Request for Class II Permissive Change

FCC ID: YZZGVC3200 Data: Nov 8th, 2015

GVC3202 is GVC3200 derivative. The main difference is that GVC3202 main board removed the HDMI OUT3 Interface and replaced the OLYMPUS lens with UNION len.

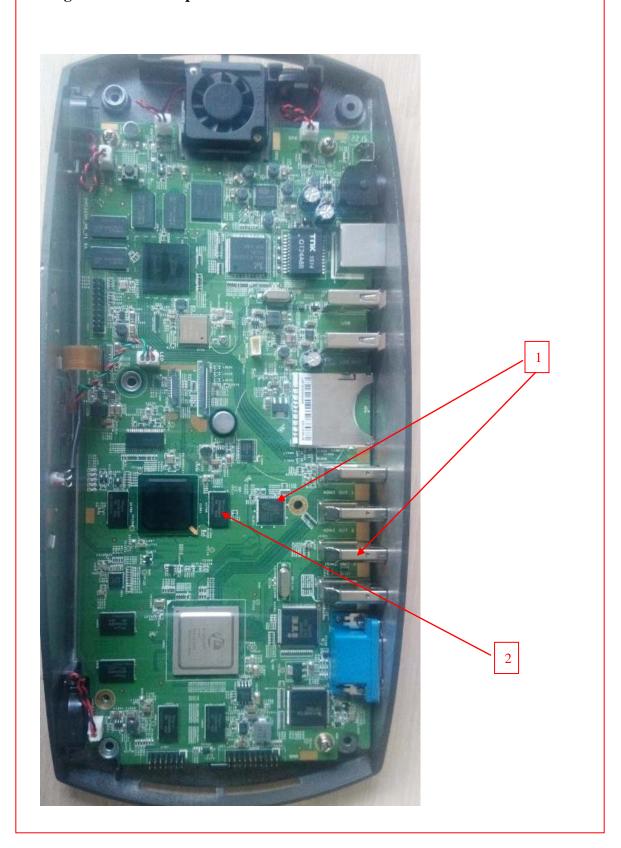
- 1. Removed the HDMI OUT3 socket J1201; Removed the HDMI transmitter U1201; Removed the HDMI OUT3 TVS array.
- 2. Removed the FPGA DDR3 memory U1702.
- 3. replaced the OLYMPUS len with UNION's.
- 4. The fixing holes on the sensor board moved 3mm further away from the PCB edge in the horizontal direction.
- 5. The socket CON1 on the lens-driver board moved 3mm further to the near PCB edge in the vertical direction.
- 6. Wireless module and it's antenna is exactly identical as before.
